ERRATA SHEET FOR ANSI/ASHRAE/IES STANDARD 90.1-2010 (SI edition) Energy Standard for Buildings Except Low-Rise Residential Buildings

March 17, 2025

The corrections listed in this errata sheet apply to ANSI/ASHRAE/IES Standard 90.1-2010, SI edition. The first printing is identified on the outside back cover of the standard as "Product Code: 86269 4/11", the second printing is identified as "Product Code: 86269 8/11 Errata noted in the list dated 07/20/2011 have been corrected.", the third printing is identified as "3/12", and the fourth printing is identified as "10/13". Shaded items have been added since the previously published errata sheet dated August 30, 2022 was distributed. Items identified with an asterisk "*" apply only to the first printing and have already been incorporated into the second printing (included in 7/20/2011 errata). The item highlighted in yellow applies only to the third (3/12) and fourth (10/13) printings and are correct in the other printings of the standard.

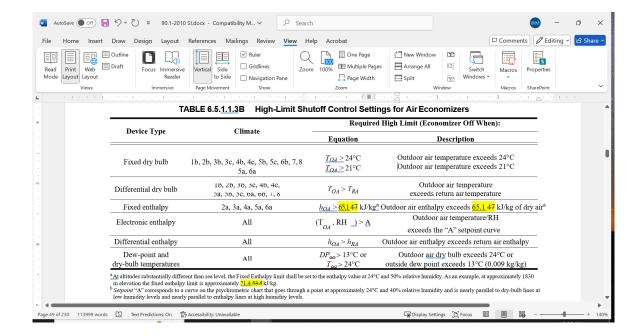
- **TABLE 6.5.1.1.3B High-Limit Shutoff Control Settings for Air Economizers.** Revise Table 6.5.1.1.3B as shown in the attached.
- **TABLE 6.5.4.5 Piping System Design Maximum Flow Rate in L/s.** Change "1" L/s to "11" L/s for Nominal Pipe Size 90 mm in column 2 (≤2000 Hours/Yr, Other).
- TABLE 6.8.1D Electrically Operated Packaged Terminal Air Conditioners, Packaged Terminal Heat Pumps, Single-Package Vertical Air Conditioners, Single-Package Vertical Heat Pumps, Room Air Conditioners, and Room Air-Conditioner Heat Pumps Minimum Efficiency Requirements. In the first and third rows of Table 6.8.1D, in the column titled Minimum Efficiency, replace "EER" with "COP_c" as shown below. (Note: Additions are shown in underline and deletions are shown in strikethrough.)
